DEPARTMENT OF THE AIR FORCE
HEADQUARTERS 377TH AIR BASE WING (AFMC)

The attached figure is submitted in response to your letter regarding the Groundwater Disposition Work Plan dated September 29, 2015. The letter requested that Figure 1 of the work plan be revised to clarify that the groundwater treatment system shown is a "full-scale" treatment system and not a "permanent" groundwater treatment system. The current pump and treat action is an interim measure and not a final remedy; a final, permanent treatment system requires evaluation as part of the Corrective Measures Evaluation process. Figure 1 has been revised to make this clarification.

RAPID RESPONSE GROUNDWATER
DISPOSAL WORK PLAN
BULK FUELS FACILITY
KIRTLAND AIR FORCE BASE, NEW MEXICO

KAFB-7 AND PERCOLATION
TESTING LOCATIONS

FIGURE 1

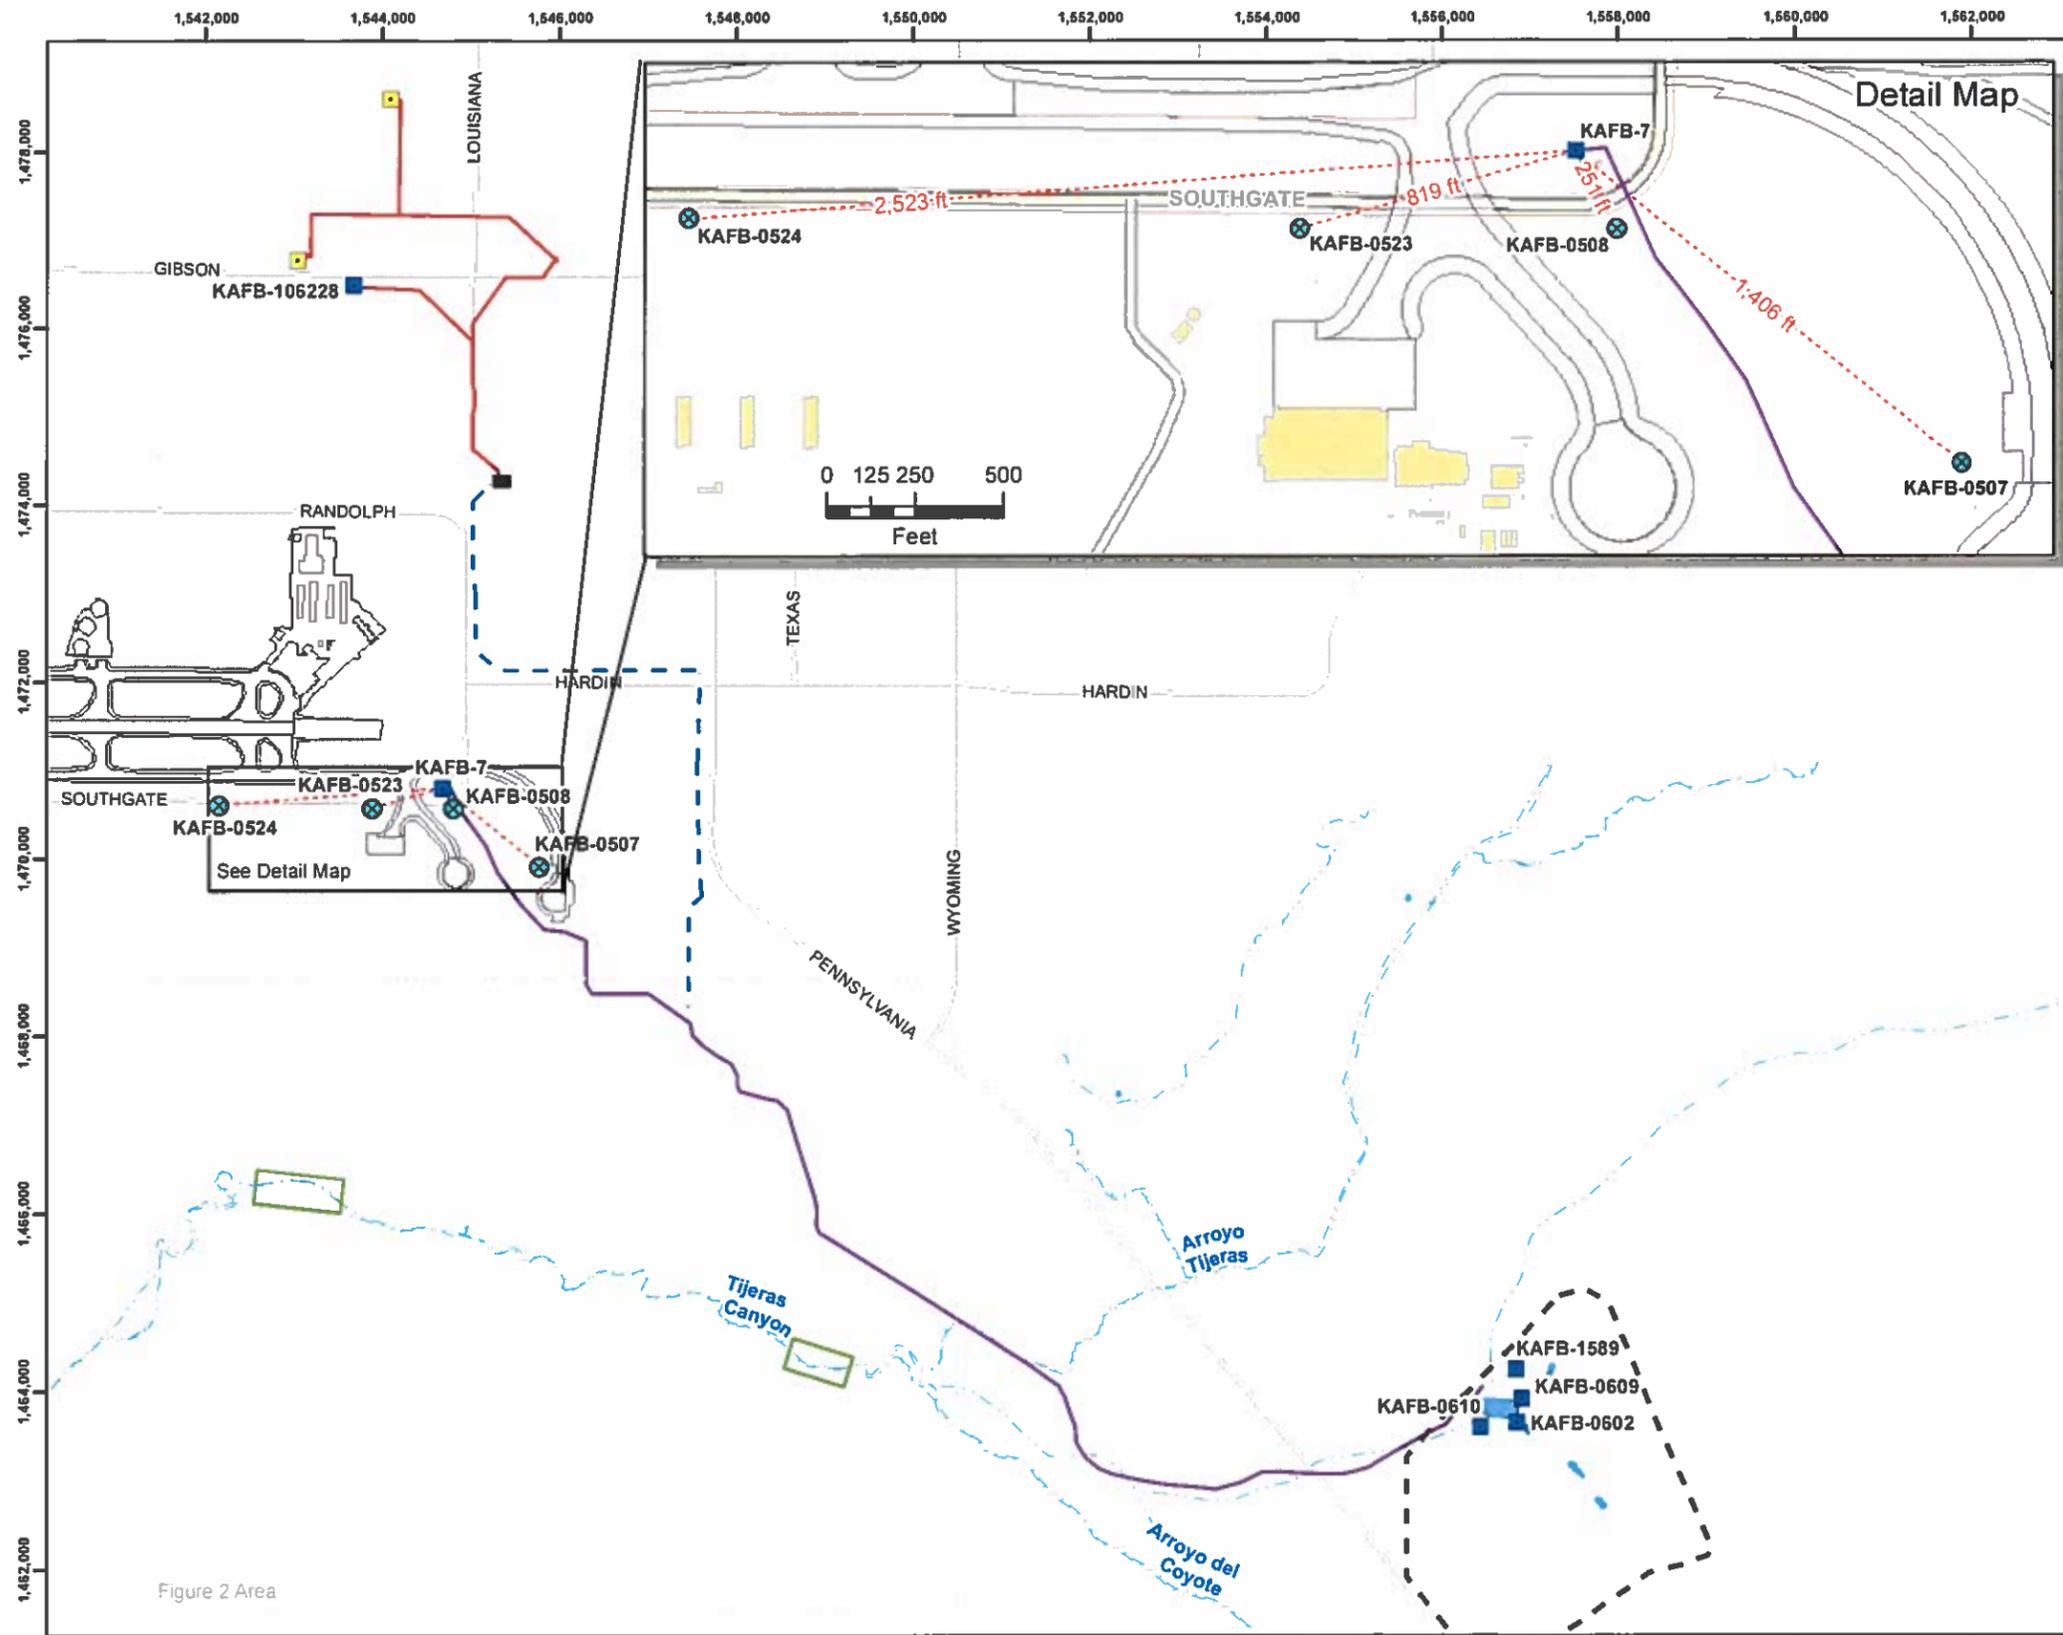
In addition, Figure 1 has been revised to reflect the use of two different wells for monitoring at KAFB-7. During the initial field visit to the wells it was found that KAFB-0521 had a large amount of downhole equipment installed that precludes the use of a transducer at that well. KAFB-0508 will be used instead. It was also determined that KAFB-2626 was screened in the perched aquifer. As a result, KAFB-0524 will be used for background monitoring.
